# SERVICE BULLETIN

**Number:** SB9809

**Subject:** Throttle setting on Z Series Riders

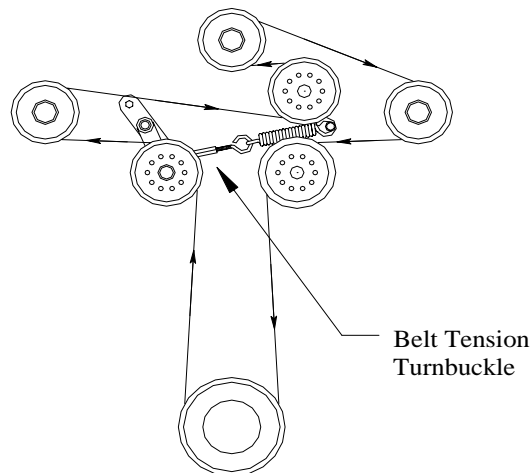
Spring tension on the tensioning idler should be set at 4 1/2" to 4 3/4" of coil stretch.

To adjust the belt tension, remove the deck plate to expose the tensioner assy. By turning the turnbuckle clockwise, tension will be increased. Turning the turnbuckle counter-clockwise will decrease tension.
